ENGINEERING BULLETIN No. 16

**Recommended Repair for Cracks in Rear Fin
Spar at Upper Hinge Bracket**

Aircraft affected: All Luscombe Model 8 Series up to and including Serial No. 1776.

REINFORCEMENT PLATE-
LUSCOMBE PART #18451
MAT'L: .040 17ST ALC.

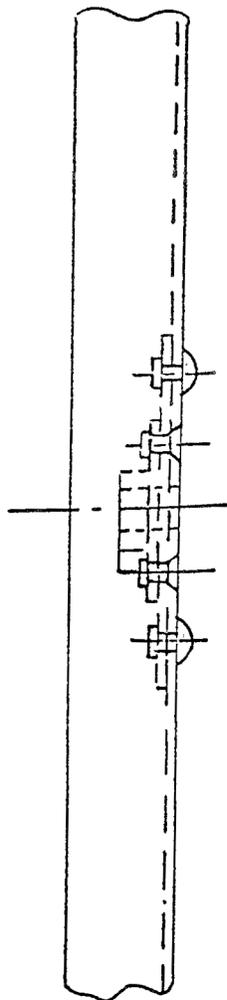
The occurrence of cracks in the rear fin spar at the upper hinge bracket has led to the addition of a reinforcement plate on all fin spars for new aircraft at our factory. The Civil Aeronautics Administration has been informed of these facts, and it will probably recommend or insist that all Luscombe aircraft manufactured before this addition be inspected and that all aircraft having these failures be repaired as outlined below and illustrated on the accompanying page.

1. Should the reinforcement plate (Luscombe part #18451) be insufficiently large to fully cover all cracks, or should any crack be more than one-half inch long, the spar should be replaced.
2. Providing the spar is repairable, remove enough rivets to allow the fin skin to be peeled back sufficiently to allow room for a dolly, and remove anchor nut (AC 366-F428).
3. Relieve all cracks with a #30 (.1285) drill.
4. Drill spar to match reinforcement plate.
5. Rivet plate in place.
6. Drill plate to match anchor nut.
7. Rivet a new anchor nut in place.
8. Replace removed rivets in skin.

PLATE NUT
AC 366-F428

$\frac{3}{32}$ A17ST C'T'SK
RIVETS (2)
DRILL 'F' (.257)

DRILL #40 (.098) (6)
 $\frac{3}{32}$ A17ST B.H.
RIVETS (4)
